ADDENDUM NUMBER THREE

PARKING LOTS MBWWTP TRAINING CENTER CONTRACT NO. W-15-019-202

CITY OF CHATTANOOGA, TENNESSEE

August 25, 2016

SHEET:	S-1A
--------	------

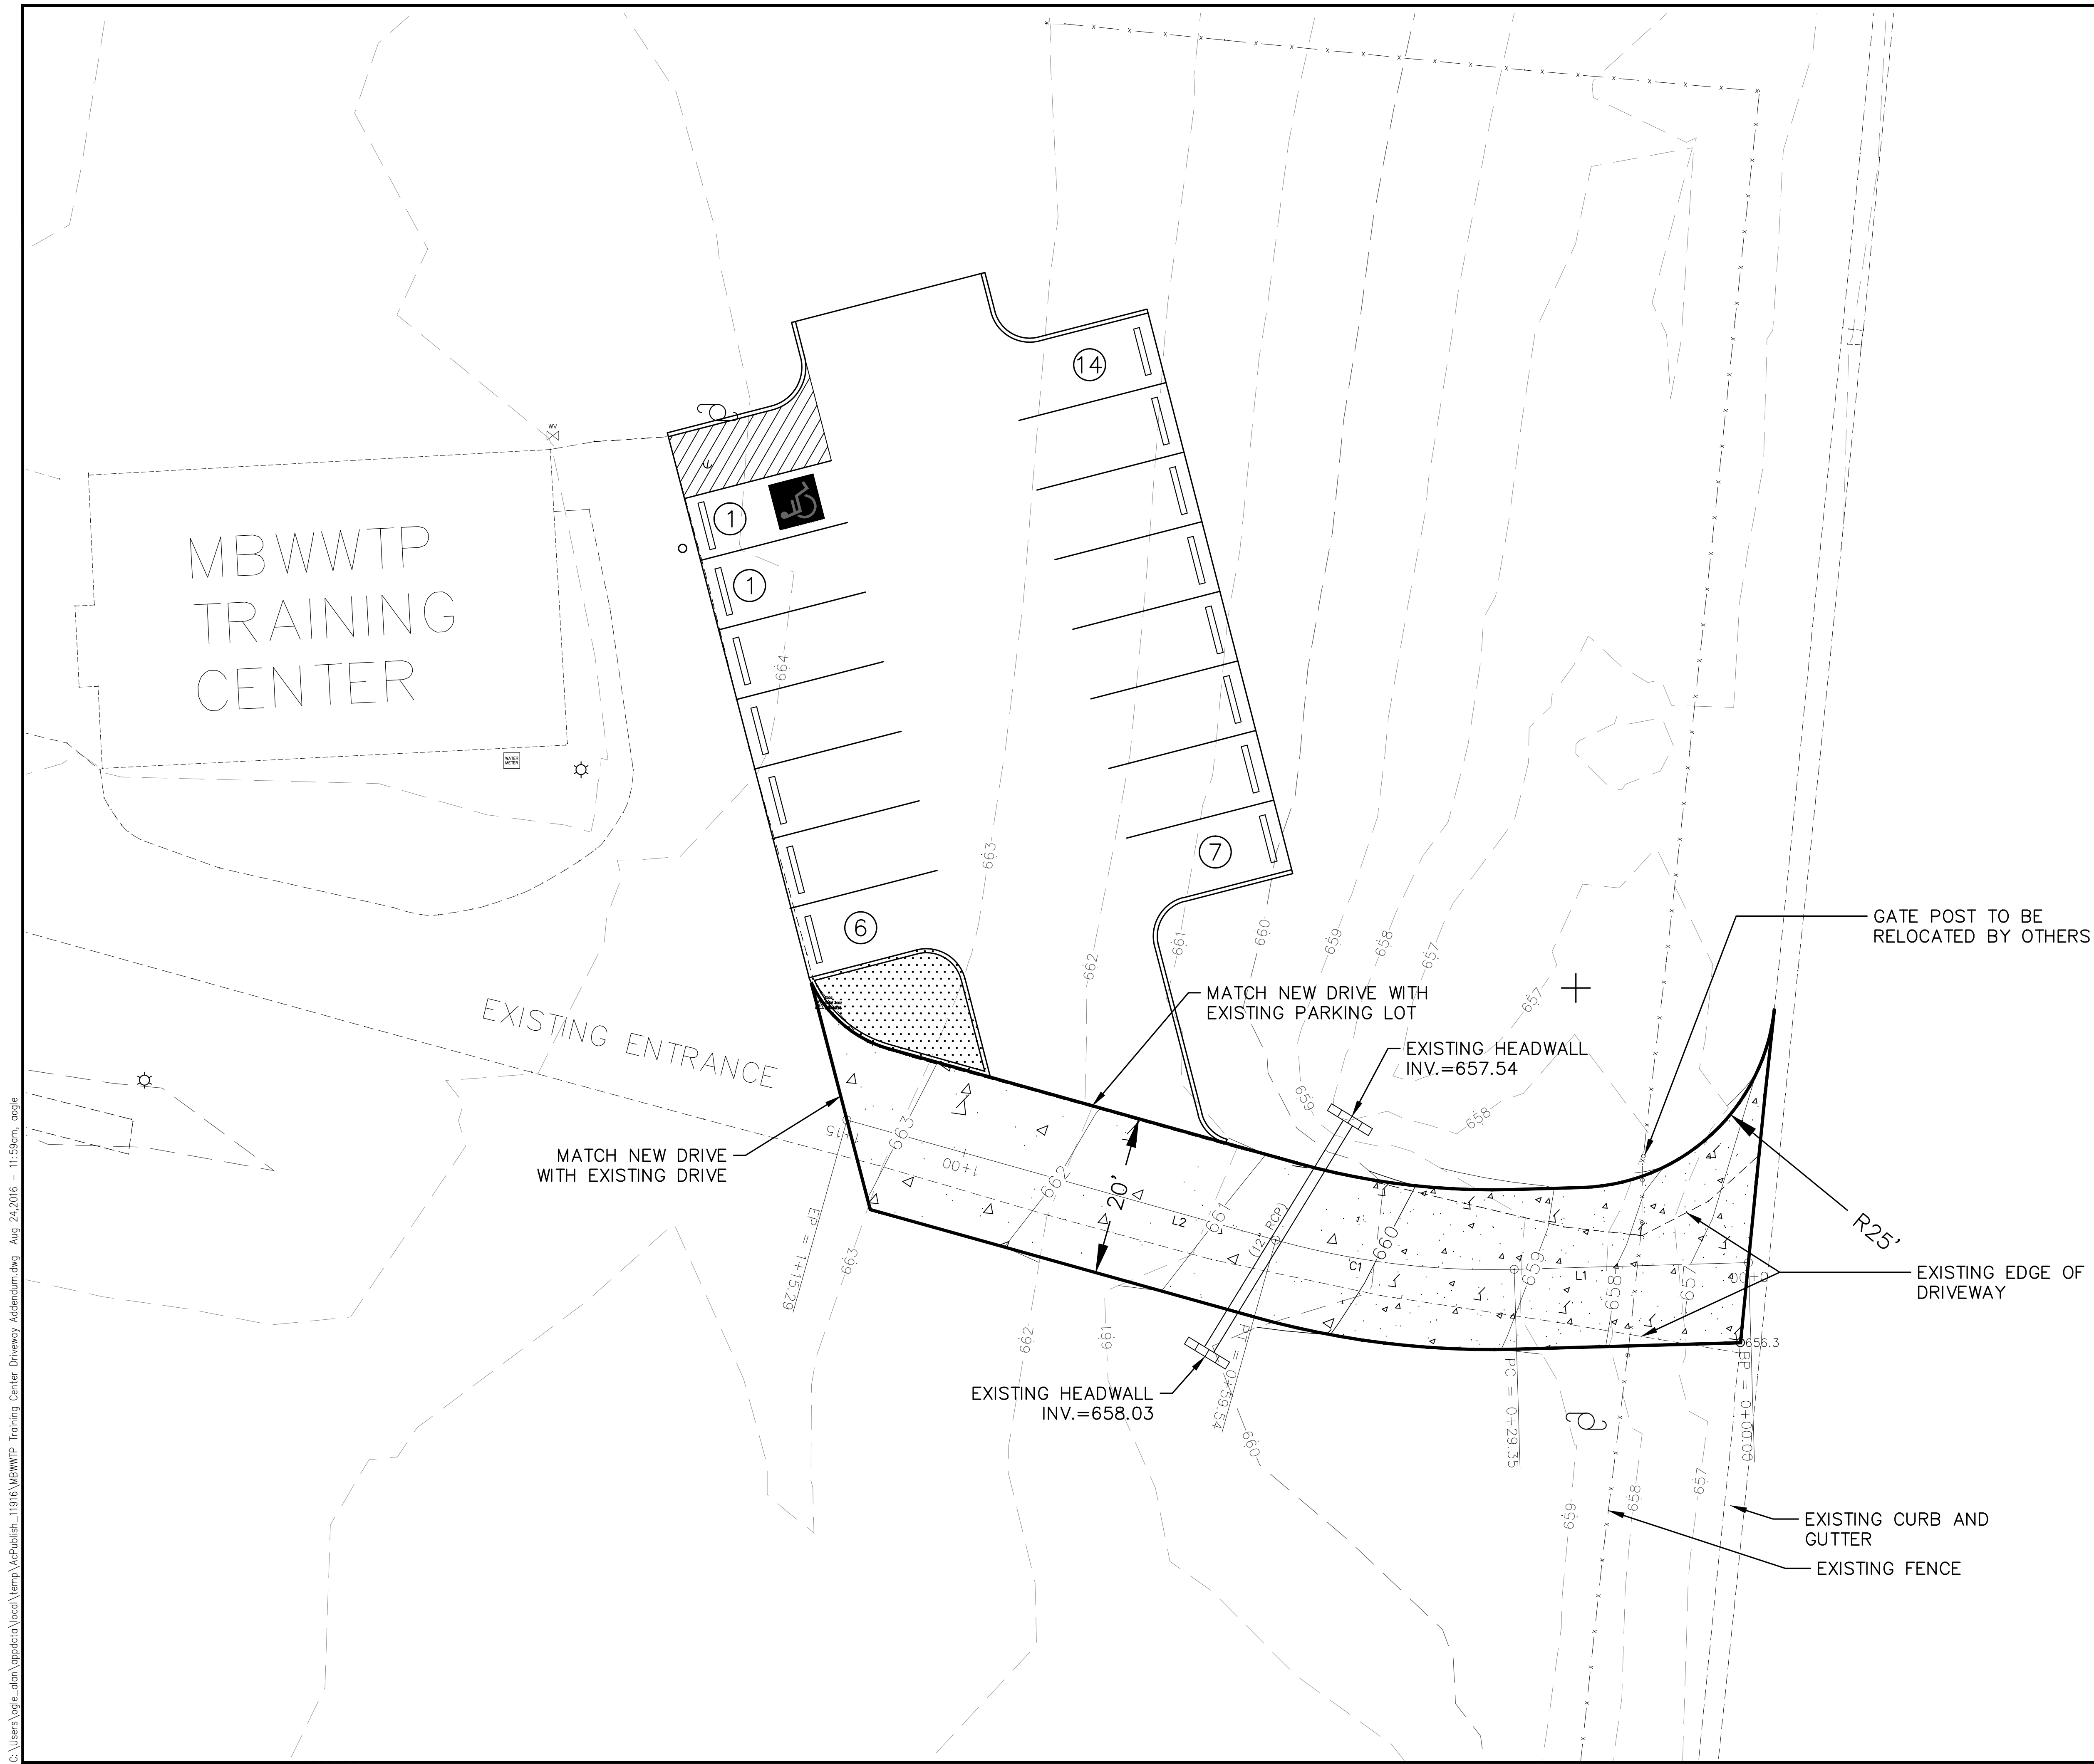
The scope of work has been revised, to include replacing approximately 115 feet of the driveway entrance to the training center. New plan sheets S-1A, P-1A, and ESC-1A are attached.

NOTE:
DRIVEWAY TO BE LIGHT DUTY
ASPHALT PAVING
PER CITY STD 200.02.

FIRST 50' OF NEW DRIVEWAY SHALL BE CITY STANDARD ROADWAY SECTION "MINOR ARTERIAL". REMAINING DRIVEWAY SHALL BE CITY STANDARD ROADWAY SECTION "COLLECTOR STREET".

NEW DRIVEWAY TO BE 20'
WIDE. MATCH LOCATION AND
ELEVATIONS IN THE AREA OF
THE NEW PARKING LOT AND
12" RCP.
